**11. COA-050432-2019**

19 North 29<sup>th</sup> Street

STAFF REPORT

**Partially enclose and screen-in a rear porch, and add glazing to an existing door.**

Figure 2. Rear of 19 North 29th Street, view from alley

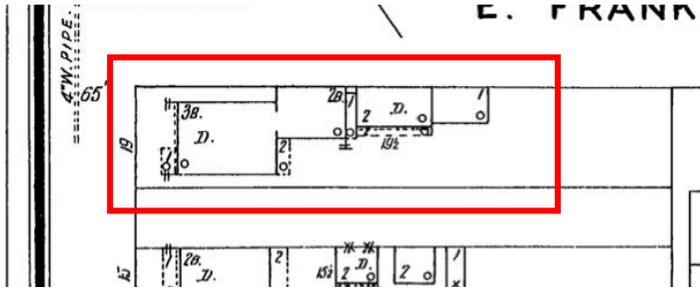
The applicant is proposing to enclose a small portion of a porch in the rear of the property. The second option presented retains the appearance of a railing, an important porch element. As details of the proposed 'false front' were not provided, staff recommends a railing element as shown in option 2 be installed, details to be submitted to staff for administrative review and approval.

The proposed single window surrounded by lap siding is not consistent with the *Guidelines* which calls for glass enclosures and recommends against solid materials. Staff recommends the existing cornice and columns be maintained and glazing be installed to the cornice and between the columns on the southwest elevation in a manner to be reviewed and administratively approved by staff to include the use of larger windows and/or transoms. This design would also be more in keeping with the design of the first story enclosure, which was constructed in 2006.

The *Guidelines* do not specifically address altering existing doors in the manner proposed. However, the *Guidelines* encourage the retention of existing doors and state that changes to windows on a secondary elevation can be considered. Staff finds that the existing door is on a secondary elevation and minimally visible from the public right of way and recommends approval of the proposed glazing.

- A railing element as shown in option 2 be installed, details to be submitted to staff for administrative review and approval.
- The existing cornice and columns be maintained and glazing be installed to the cornice and between the columns on the southwest elevation in a manner to be reviewed and administratively approved by staff to include the use of larger windows and/or transoms.
